**LEBANON PLANNING BOARD
SEPTEMBER 8, 2025 - 6:30 PM
COUNCIL CHAMBERS, CITY HALL OR
REMOTE VIA VIRTUAL PLATFORM
LEBANONNH.GOV/LIVE**

Staff Memorandum – PB2025-44-MIN

SUBDIVISION PLAN FOR
192 MASCOMA STREET, LLC
TAX MAP 90, LOT 19
192 MASCOMA STREET, LEBANON, NEW HAMPSHIRE - GRAFTON CO.

REVO CASINO PARKING EXPANSION

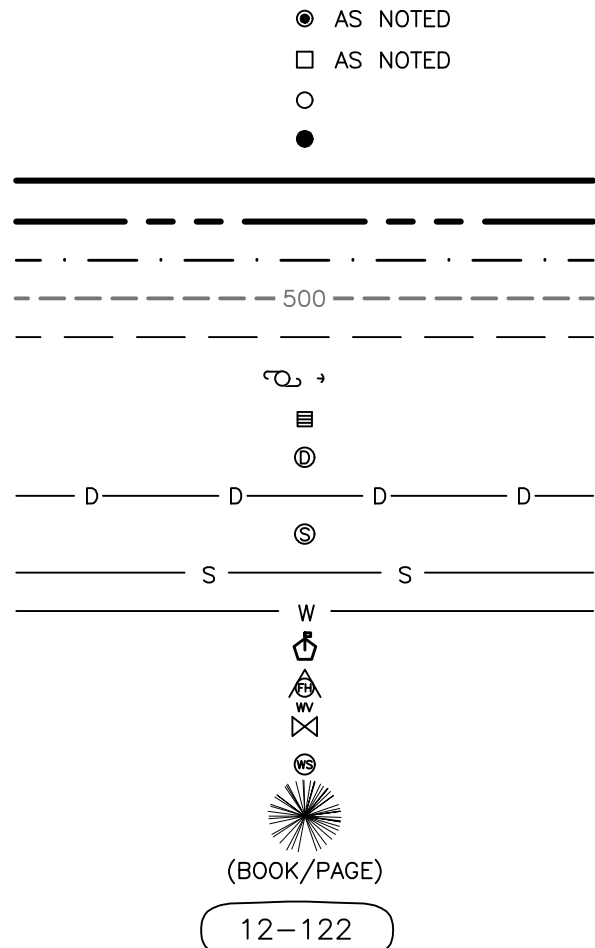
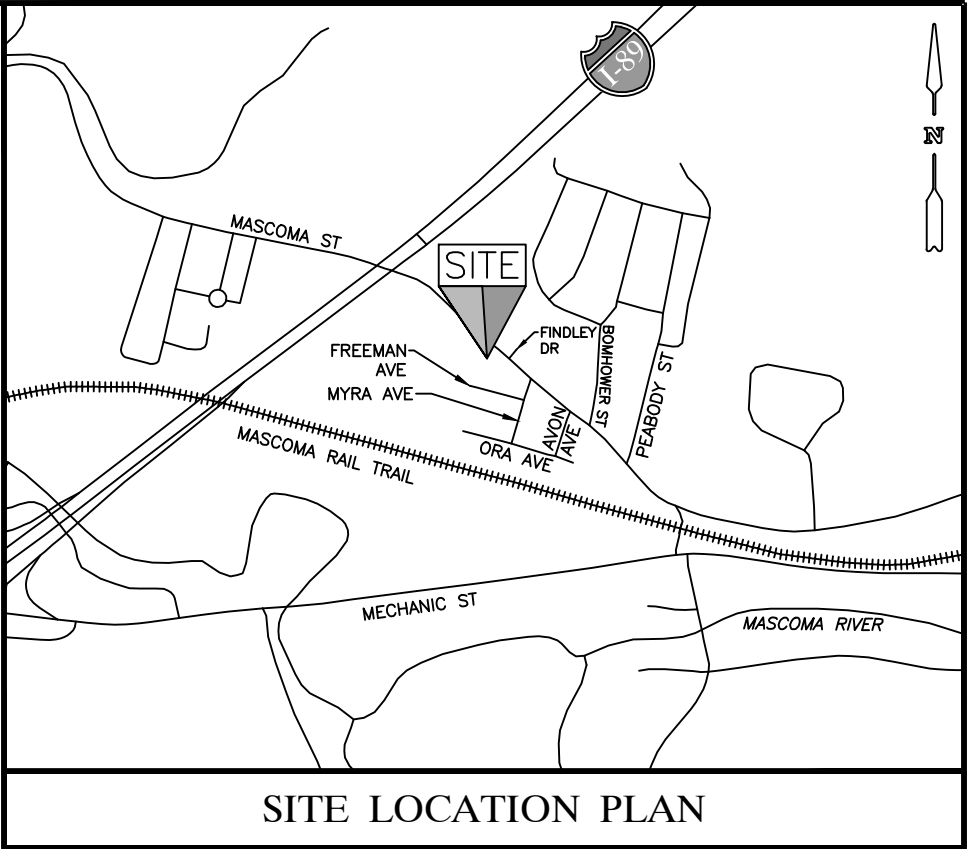
- A conceptual driveway should be added to the subdivision plan for proposed Lot 90-19-1. The City Engineer recommends Freeman Avenue. Any proposed driveways should ensure compliance with the City's Driveway Regulations and, by extension, NHDOT Driveway Regulations including layout, sight distances, grading and drainage.
- The City's turnaround easement should be updated on proposed Lot 90-19-2 to match the existing paved driveway apron.
- It is not clear how proposed Lot 90-19-2 will be serviced by municipal sewer. This should be clarified and it should be verified that the sewer main is deep enough to service the lot without needing a private sewer pump.

4. The applicant shall provide a revised plat depicting the following changes to the satisfaction of the Planning and Development Department:
 - a. Remove or relocate shed, as applicable, per condition B.1.

- b. Add a conceptual driveway consistent with *(TBD – depending on what the applicant submits for or at the public hearing to demonstrate compliance with Section 13.3.A of the Subdivision Regulations – see related Planning staff comment above)*.

2. To the satisfaction of the Department of Public Works, prepare a revised turnaround easement deed on proposed Lot 90-19-2 to match the existing paved driveway apron.

3. To the satisfaction of the City Engineer, identify how proposed Lot 90-19-2 will be serviced by municipal sewer, and verify that the sewer main is sufficiently deep to service the lot without requiring a private sewer pump.

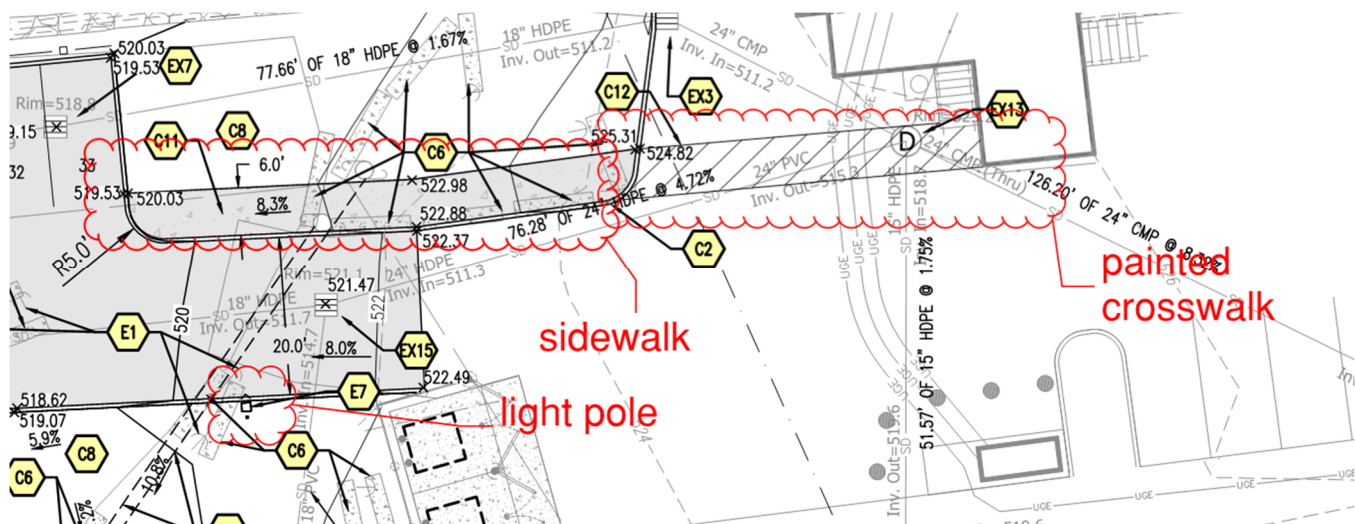
Here, it appears that the applicant has not "supplemented" the perimeter of the proposed parking area with either shrubs, perennials, or understory trees -- at all, let alone in a quantity sufficient to "screen" the parking area².

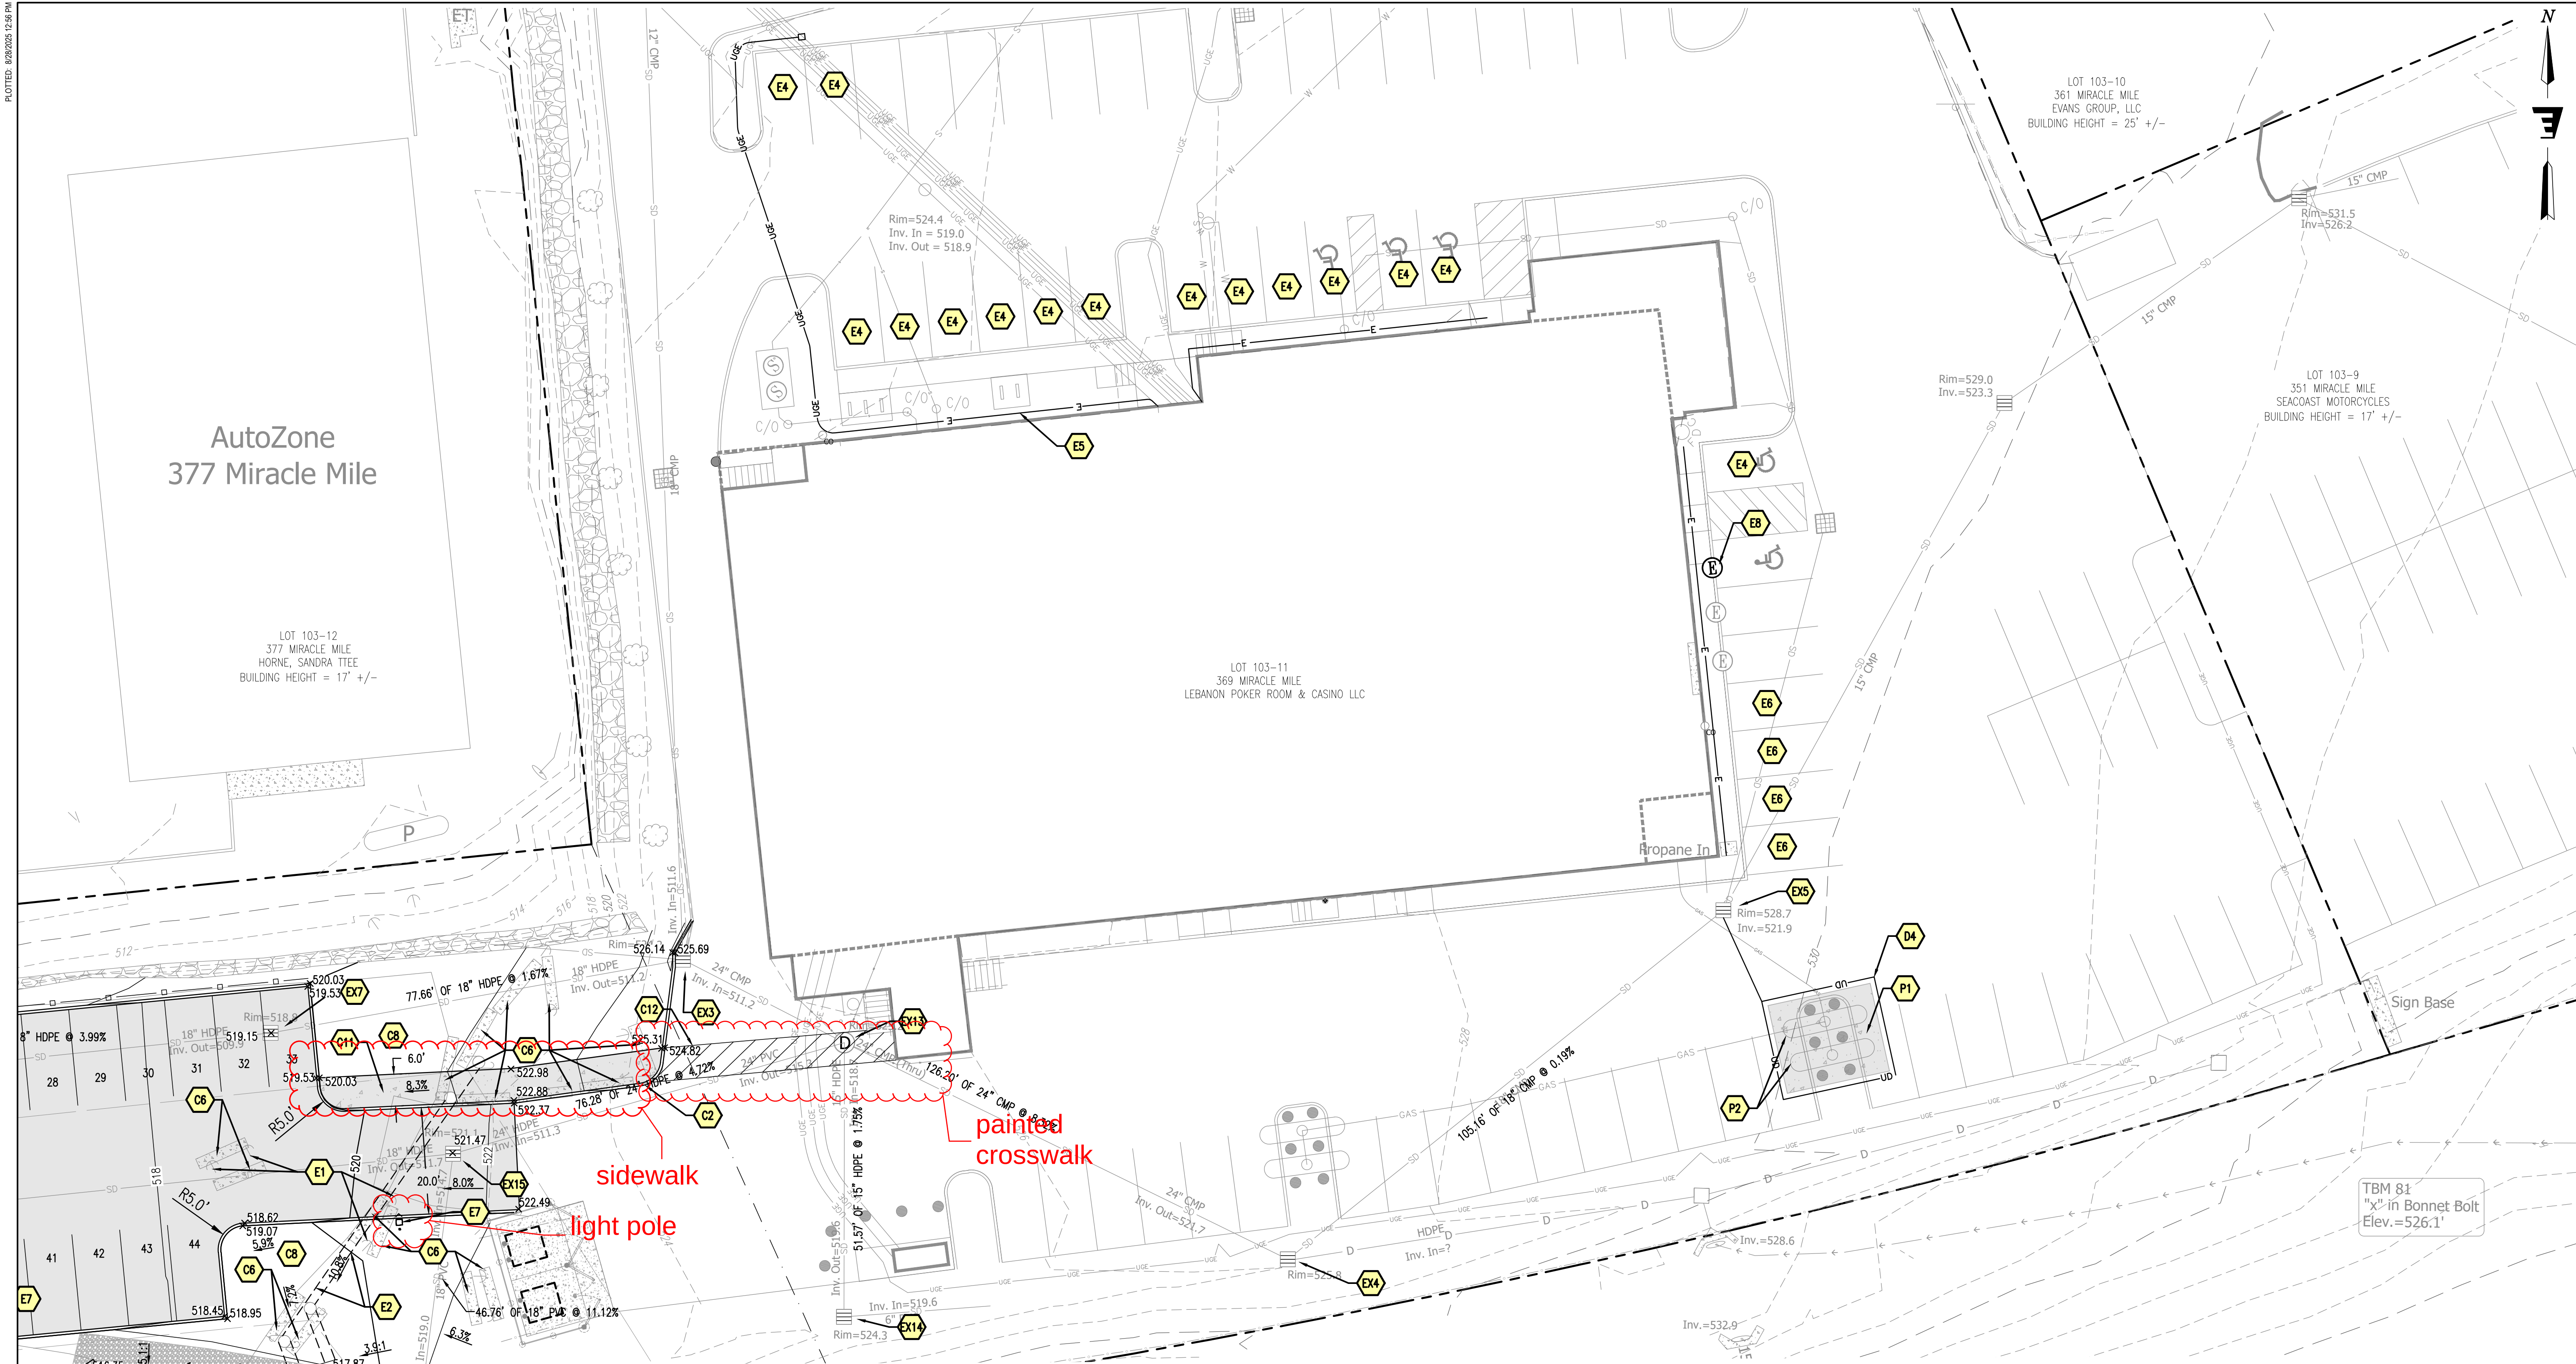
1. There are new stormwater structures and pipes proposed as part of this application. However, no rim, inverts, sump elevation information, and no pipe slope, type, length information has been provided. *The rims and invert information has now been added to the plans, see revised sheets C2.1 and C2.2*

SHEET 11 OF 13
Page 66 of 120

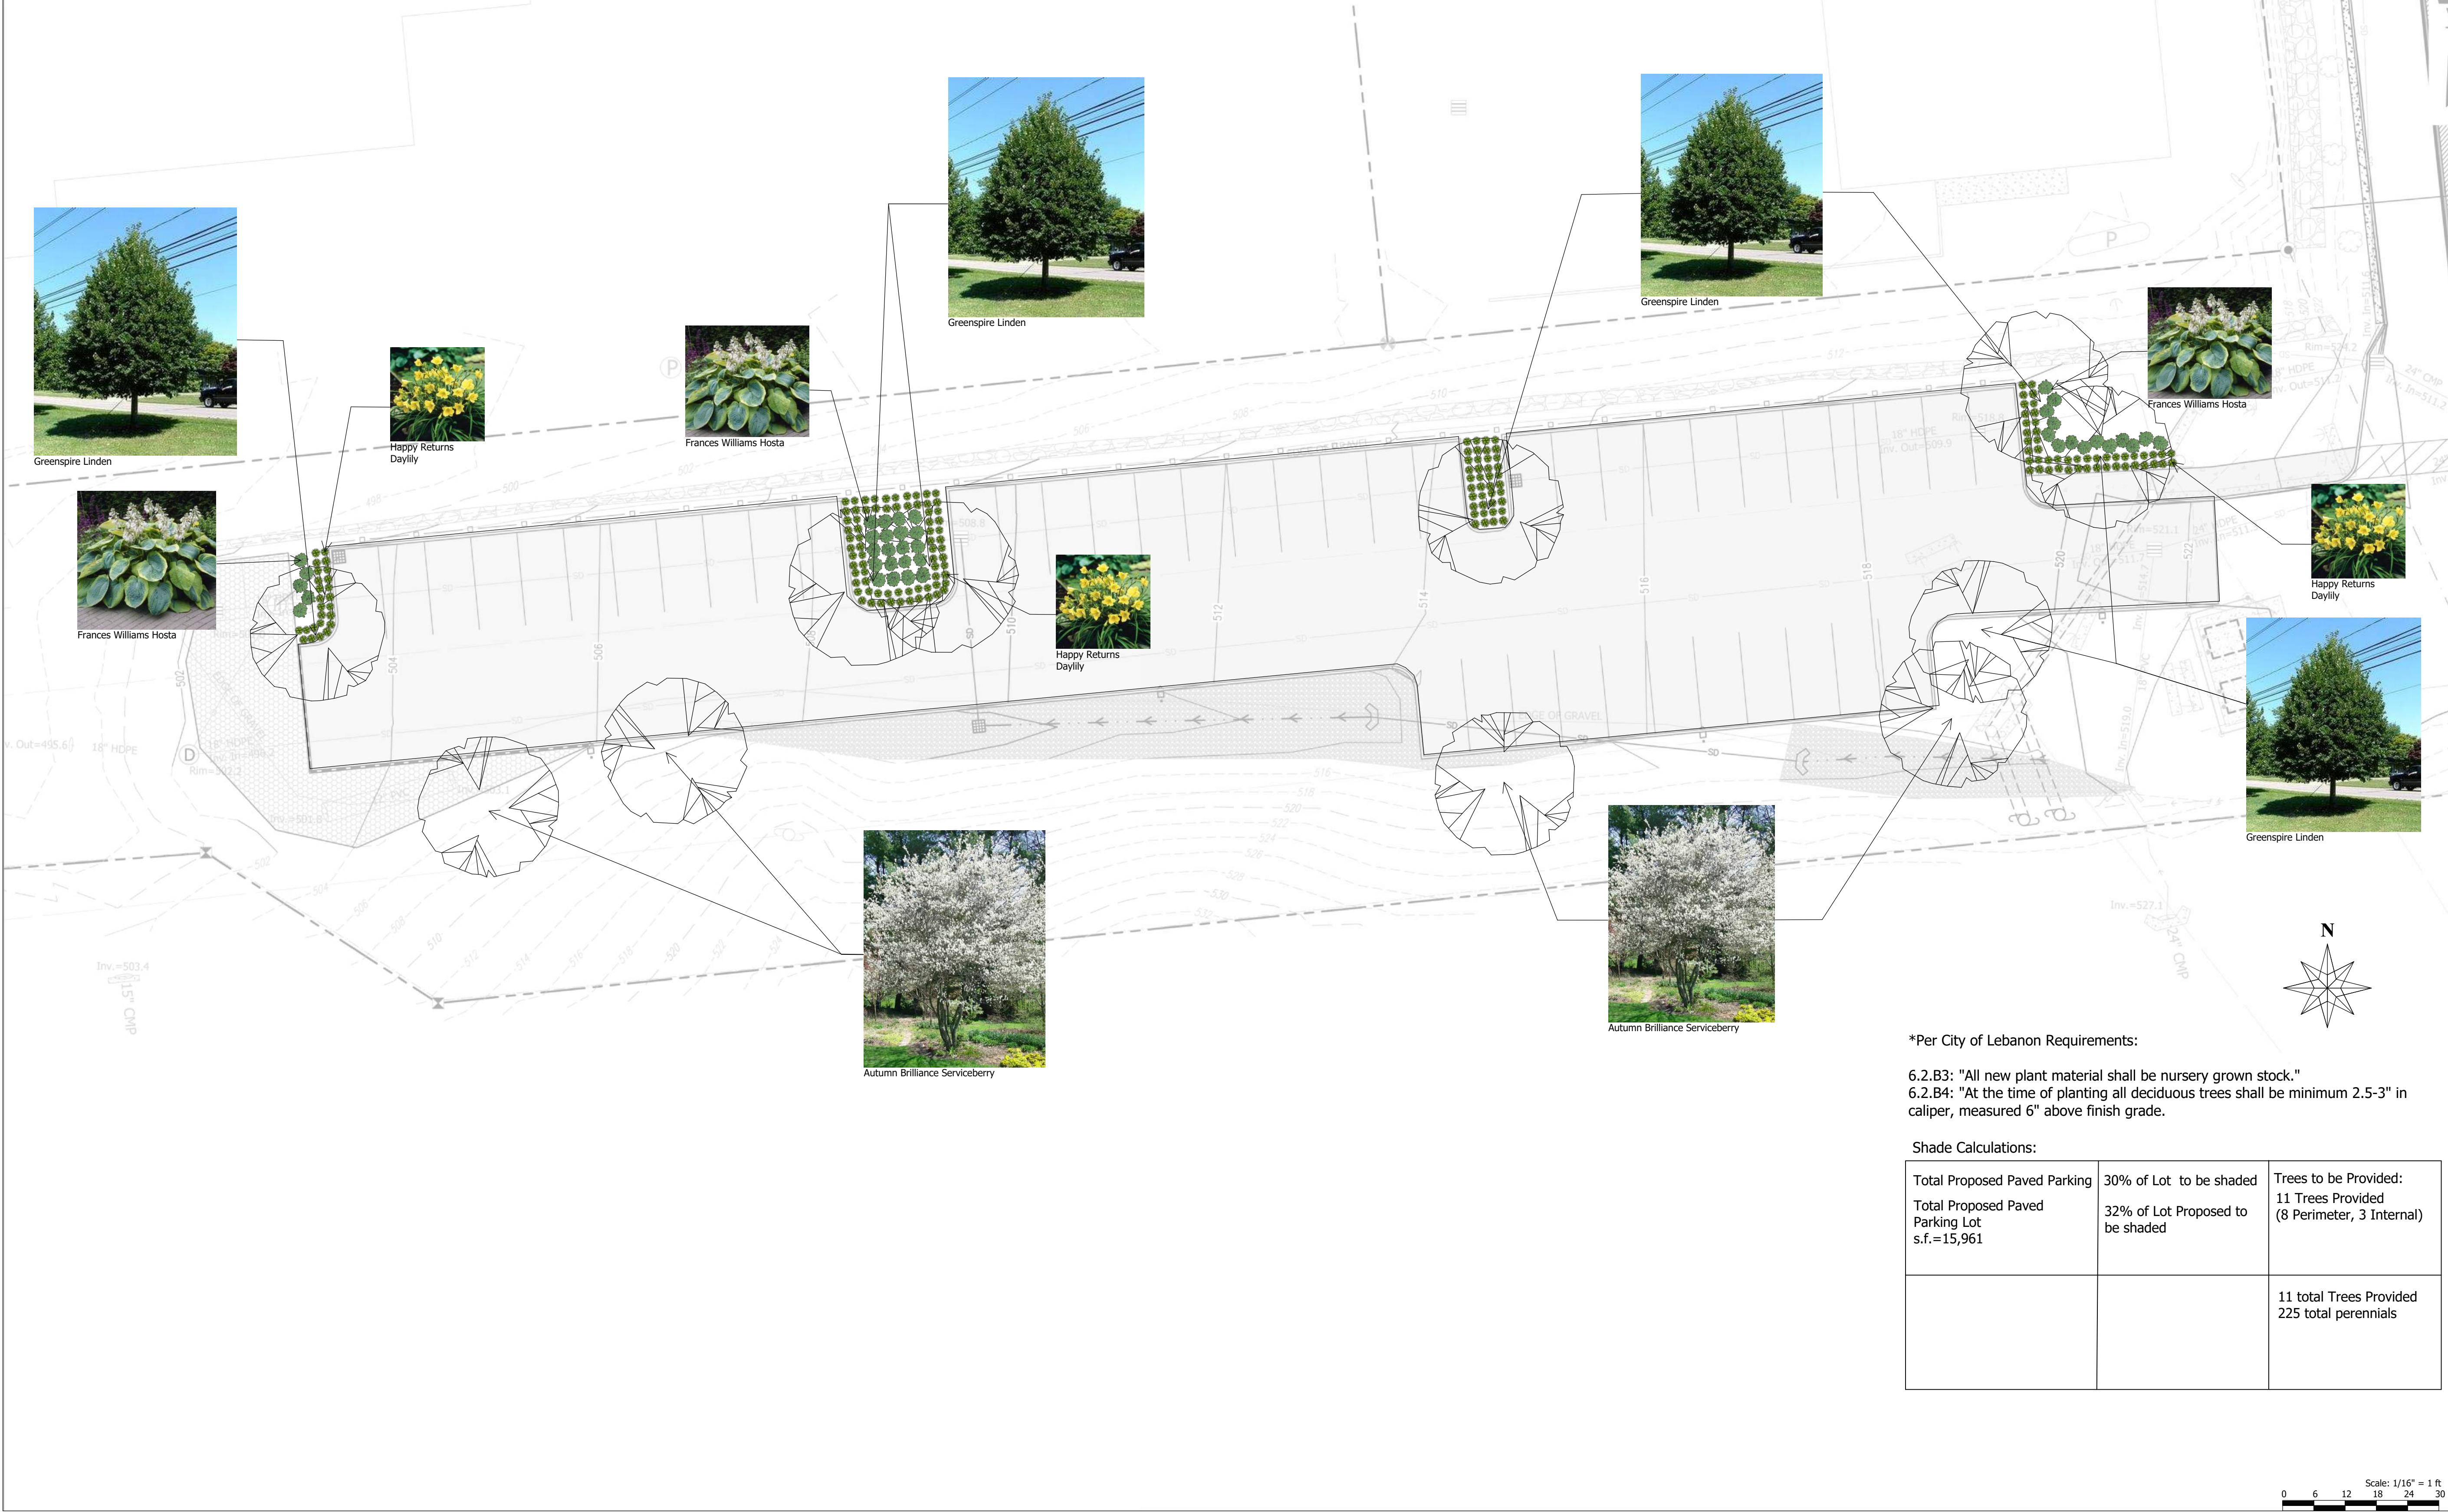
6.2 (Landscaping Standards): The applicant's landscaping plan is Sheet 11 of the plan set with landscaping details found on Sheet 12. Per the attached Application for Waivers, the applicant has requested a waiver from the perimeter landscaping requirements of Section 6.2.B.1 through 6.2.B.5.
